**TOWN OF BROOKLYN  
PLANNING AND ZONING COMMISSION  
Regular Meeting Agenda  
Wednesday, February 3, 2021  
6:30 p.m.**

## ENGINEERING PLAN REVIEW PERTAINING TO 4-LOT SUBDIVISION (ASSESSOR'S MAP 7, LOT 12-1) TRIPP HOLLOW ROAD BROOKLYN, CT (September 5, 2020)

# PROPOSED 4 LOT SUBDIVISION

Sheet No.  
**5 of 8**

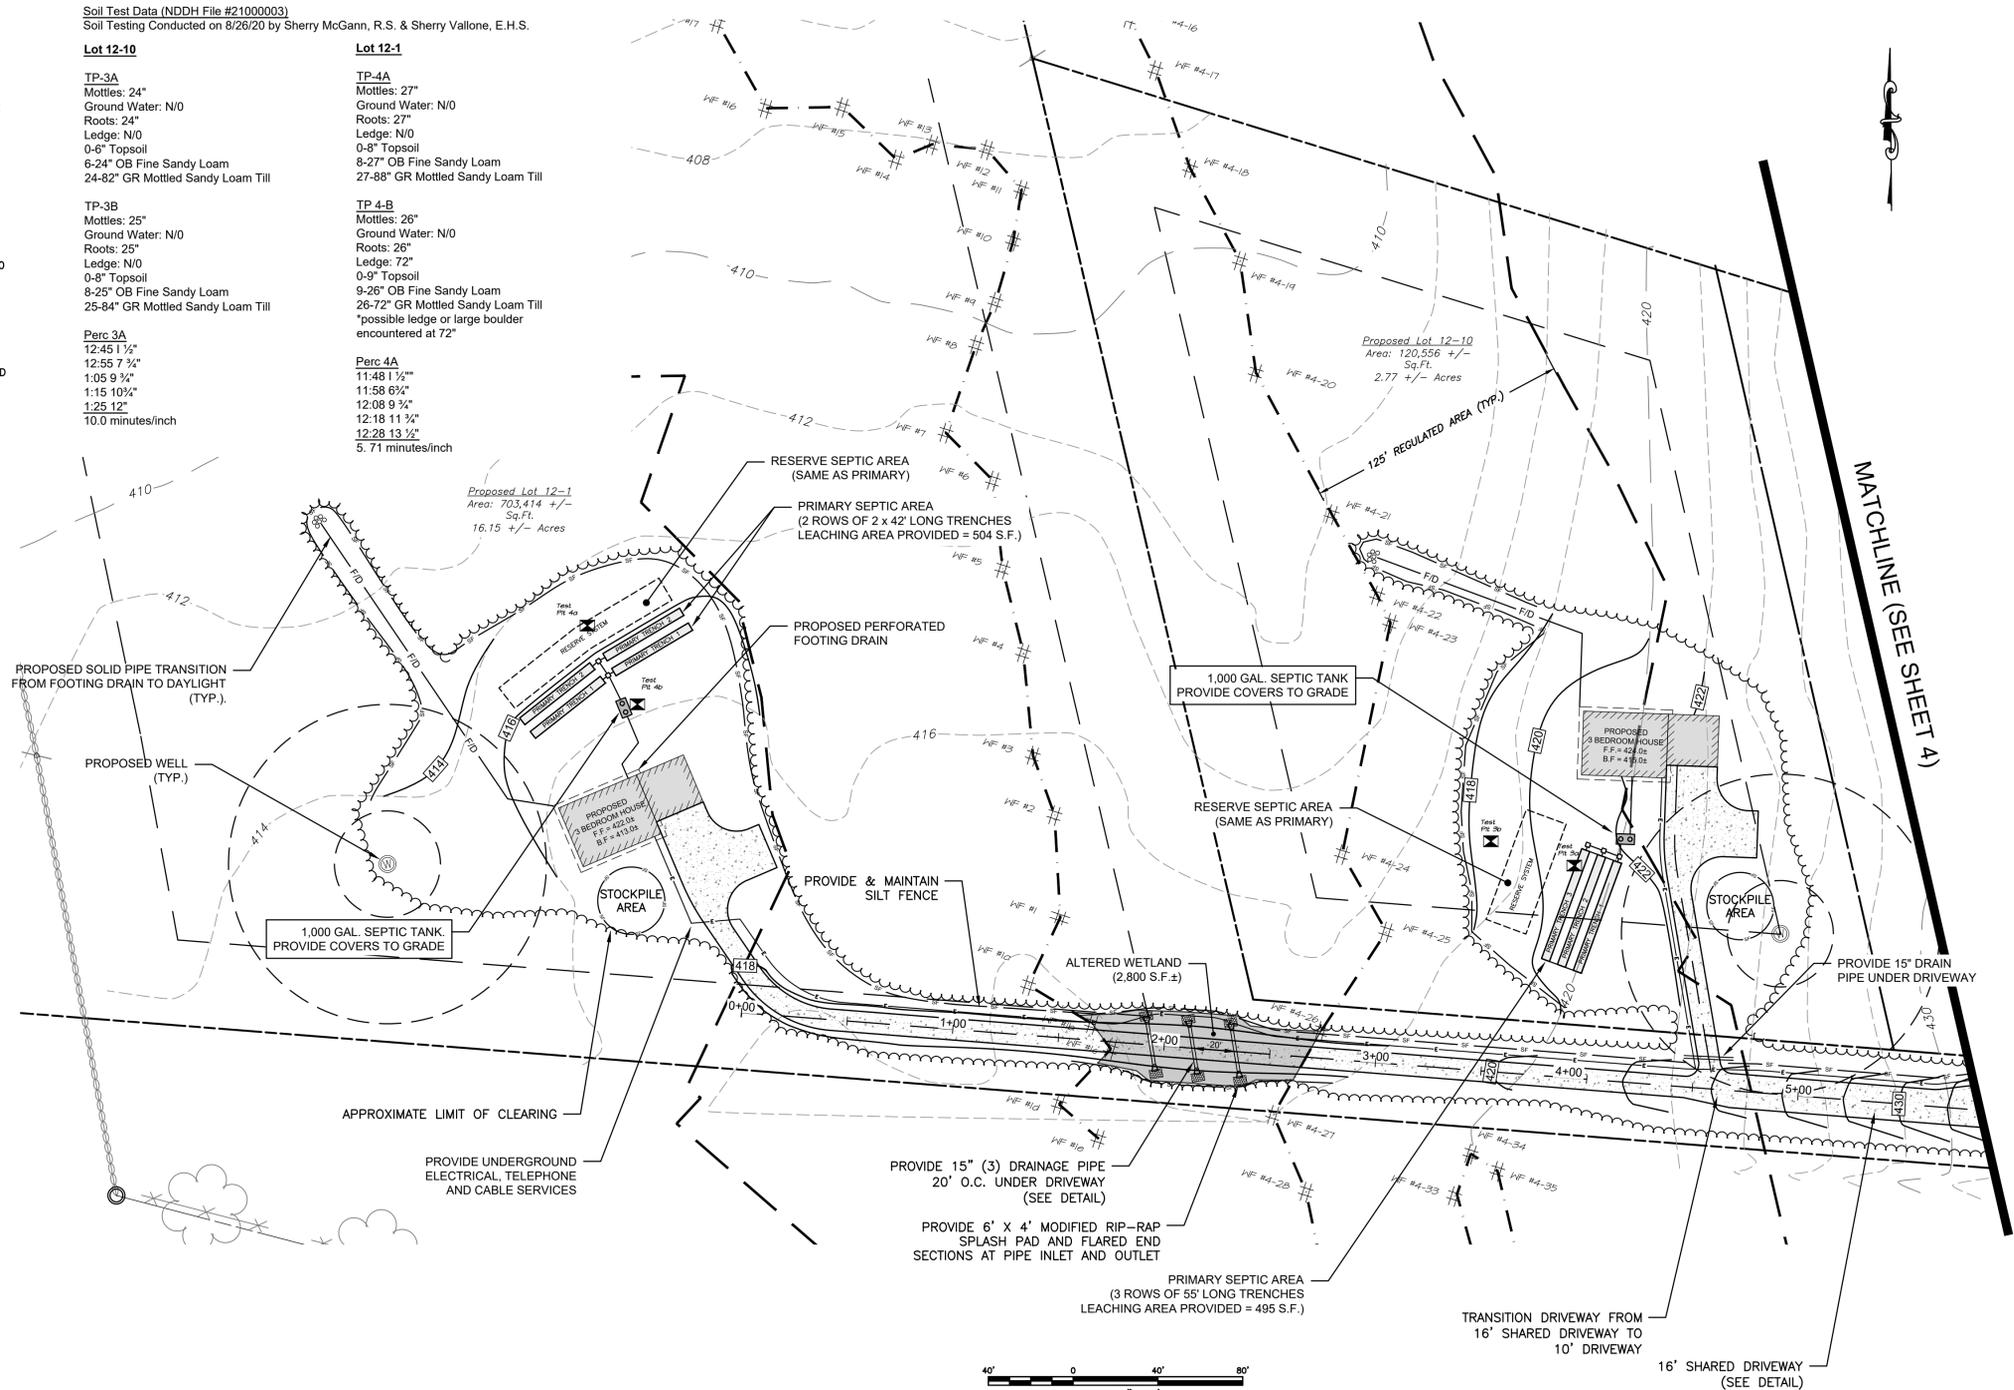
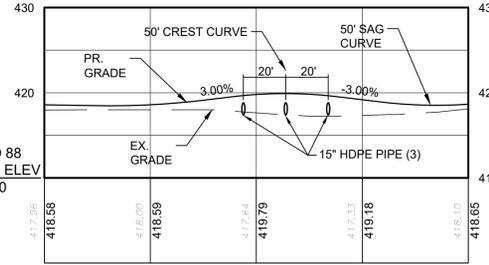
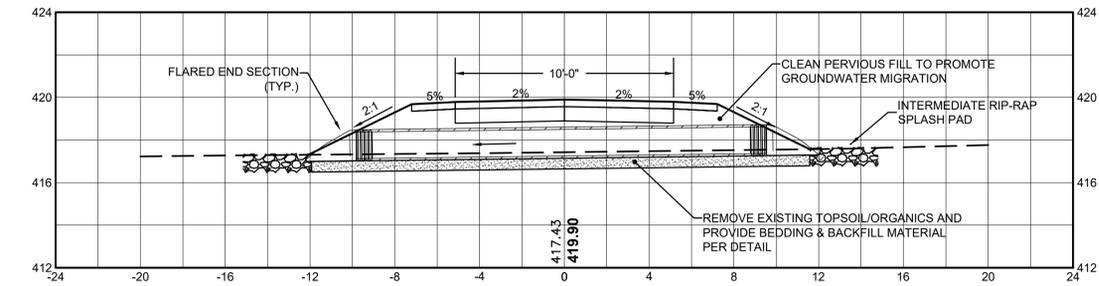
1. The area of the wetland eliminated by the proposed driveway construction and culvert installation with riprap needs to be noted on the plan.

5. The common driveway wetland crossing cross-section indicates that the twin 15" HDPE pipes will be laid on the existing ground without any bedding or other special preparation. How was it determined that the existing ground in the wetland can provide adequate support without for the pipes without them deforming when subjected to dead and live loads (H2O)? What is the consistency of the existing ground?

The Applicant's engineer did not provide any information as to the consistency and depth of unsuitable material in his response. This needs to be addressed to ensure adequate support is provided for the triple pipe installation by the contractor because HDPE pipe is flexible and if not supported properly will not perform as expected and cause maintenance issues. Gravel aggregate used under the pipes must have a material gradation designation as specified in Connecticut DOT Form 818.

7. Flared end sections are needed on the ends of each 15" HDPE pipe to improve flow into and out of the pipes as well as protecting the ends of the pipe from scour. A flared end detail is needed to be included on the Construction Details plan.

This comment was NOT addressed and requires a response. Flared ends protect the end of the pipe as well as providing support to the embankment formed around the end of the pipe. Flared end sections are necessary. If a flared end is not used then a poured concrete headwall must be installed to provide the same protection. A detail is needed in either case. How and why did IWWC commission members discuss and make a determination during a site visit meeting that a third pipe was necessary?

8. A construction detail showing the separation between the 15" pipes needs to be included on the Construction Details plan.

This comment was NOT addressed and requires a response. It is important to maintain proper spacing between pipes to prevent water from finding a pathway around the exterior of the pipe and for future ease of maintenance, if required. A construction detail is necessary.

9. Underground electric, telephone and cable service is shown on the plan crossing the proposed twin 15" HDPE pipes. How this crossing will be made is not shown in the wetlands crossing driveway cross-section. If the services are installed over the pipes, there appears to only be about 16" cover over the crowns of the pipes for that installation. If service lines are to be enclosed in a conduit, telephone and

cable cannot be in the same conduit as electric. The driveway wetland crossing cross-section needs modification to show how underground utilities will cross the twin pipes.

**This comment has been addressed and no further response is necessary.**

This comment has been addressed and no further response is necessary.

This comment has been addressed and no further response is necessary.

This comment has not been addressed.

This comment has been addressed and no further response is necessary.
